Juliet W. Long HVAC Improvements

Change Order Packet

CHANGE ORDER INFORMATION:
Change Order Number: 005

Per Nutmeg Companies, Inc. PCO #04 Credit for metal panel infill, install glass block at GYM. Dated 6/18/2026, credit metal panel material and labor for louver infills, and provide glass block infill per SKA-02.

SKA-02

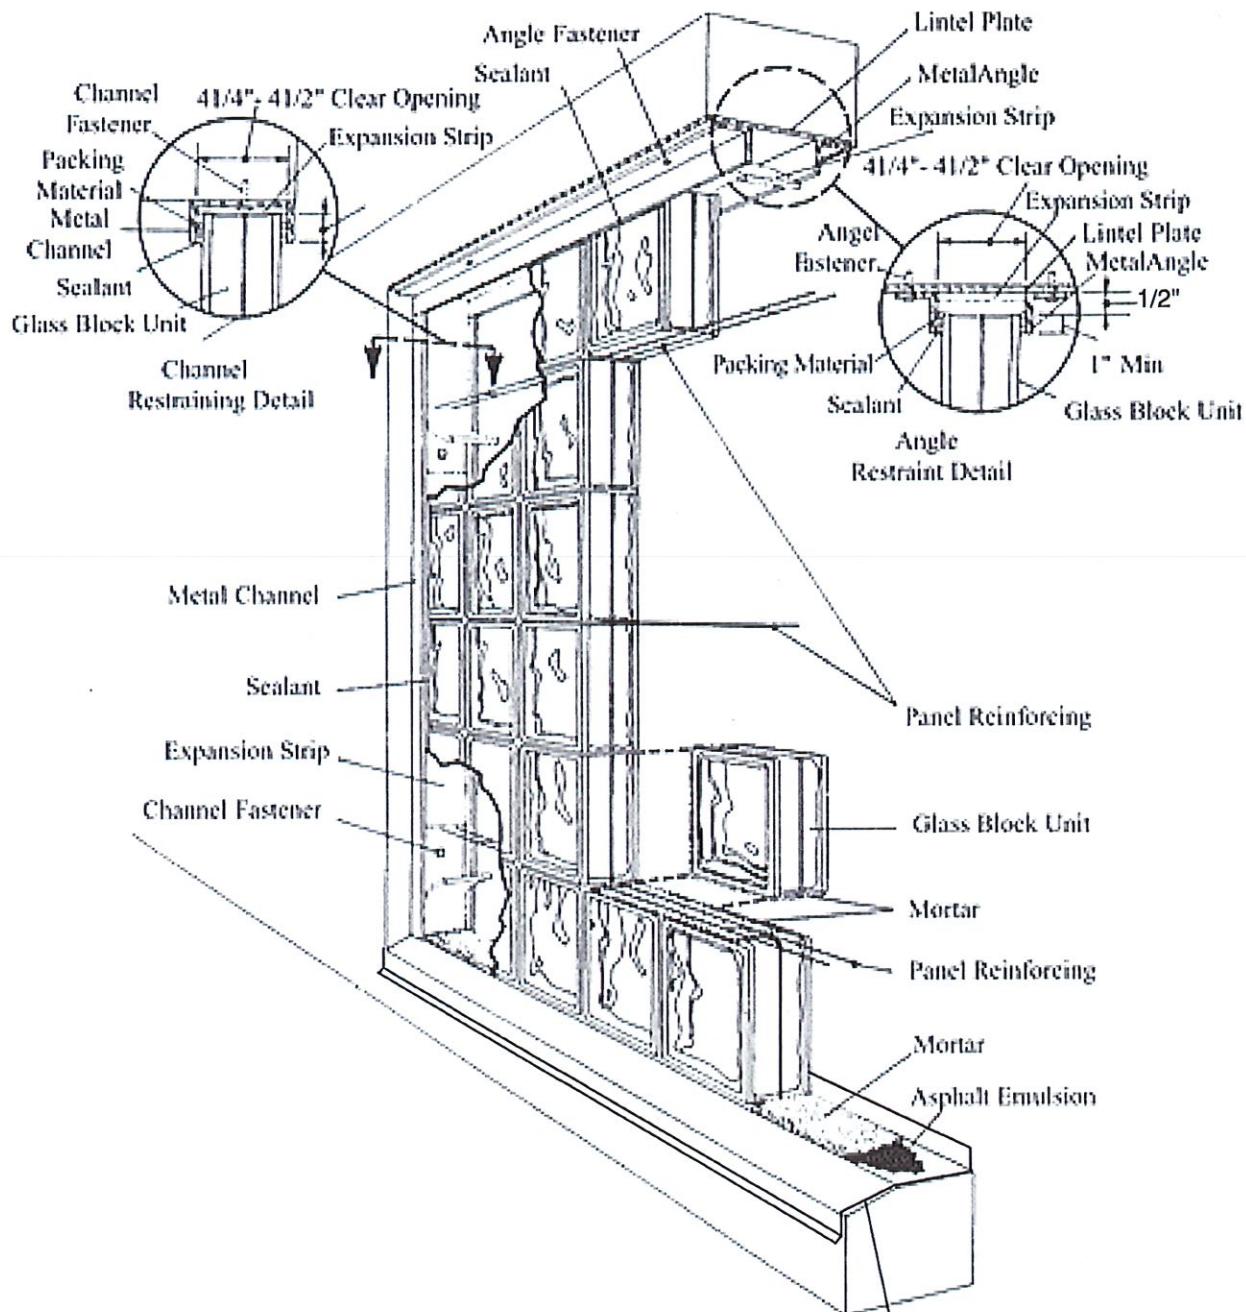
DESCRIPTION OF PROPOSAL: in lieu of providing metal panel infill at the removed GYM louver and hood we propose a credit to infill the openign with Glass Block

DESCRIPTION OF PROPOSAL: Infill existing framed louver openings at the gym with glass block.

Provide stainless steel thru-flashing with drip edge and end-dams with 1/2" min. vertical leg on interior face. Flashing to be set in bed of sealant or asphalt emulsion.
